Version with Markings to Shows Changes Made
Proposed revised Fig. 9

VERSION WITH MARKINGS TO SHOW CHANGES MADE

U.S. PATENT APPLICATION SER. NO. 09/737,138
ACCOMPANYING AMENDMENT OF APRIL 27, 2001

FIG. 9

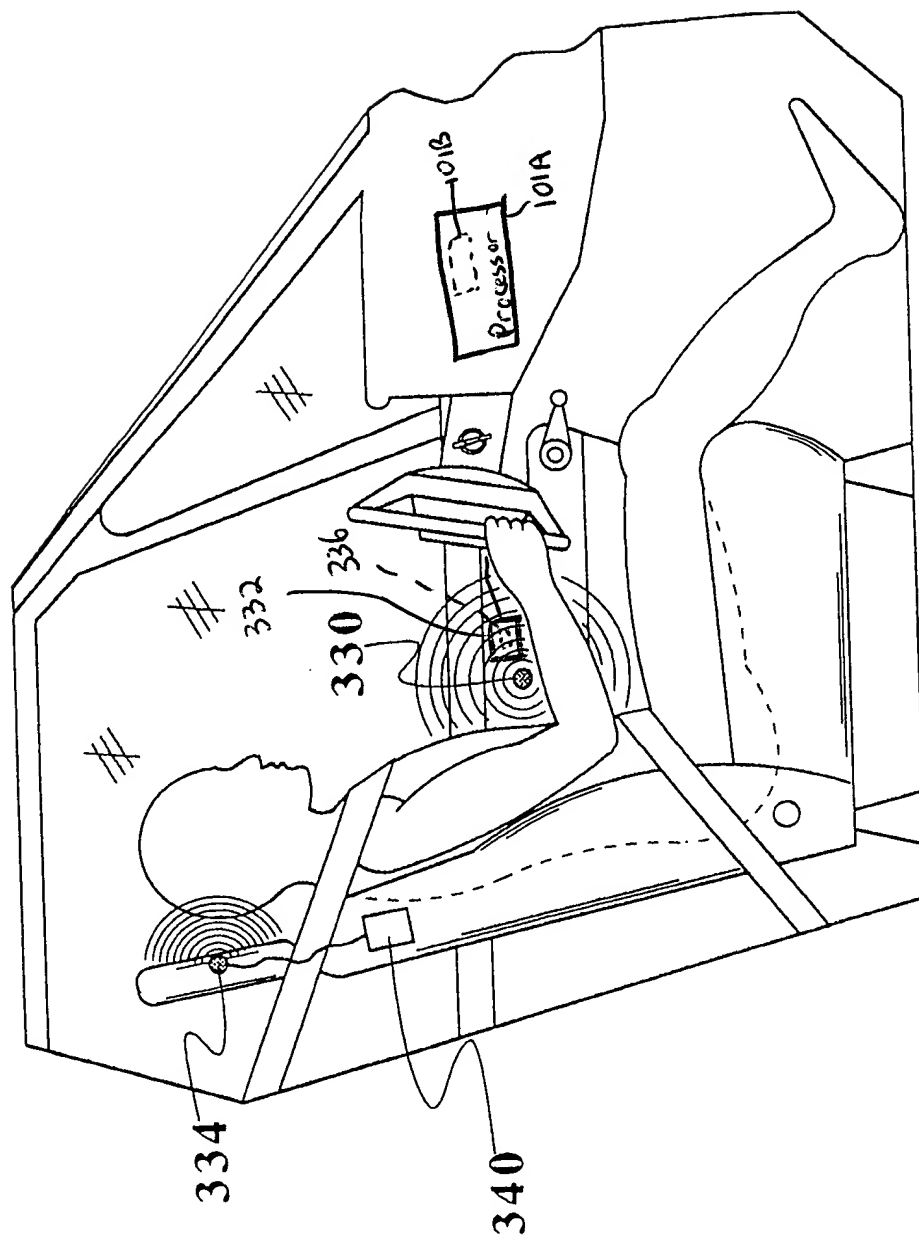
Please enter proposed revised Fig. 9 submitted herewith.

Proposed revised Fig. 9 is submitted herewith in which the side airbag is now shown along with the control circuit resident in the processor. Previously, Fig. 9 referred to the side airbag system which inherently includes an airbag. The corresponding proposed revision to the specification (the paragraph beginning at page 20, line 17) refers to Fig. 4 wherein an airbag control system for a frontal airbag is shown and which is coupled to a processor 101 coupled to the transducers.

system 332 and components of the interior monitoring system, e.g., transducer 330, are coupled to a processor 101A including a control circuit 101B (shown in dotted lines) for controlling deployment of the airbag 336 based on the information obtained by ultrasonic transducer 330. This device is not used to identify the object that is adjacent the airbag but merely to measure the position of the object. It is also understood that it can be used to determine the presence of the object, i.e., the received waves are indicative of the presence or absence of an occupant as well as the position of the occupant or a part thereof. Instead of an ultrasonic transducer, another wave-receiving transducer may be used as described in any of the other embodiments herein, either solely for performing a wave-receiving function or for performing both a wave-receiving function and a wave-transmitting function.
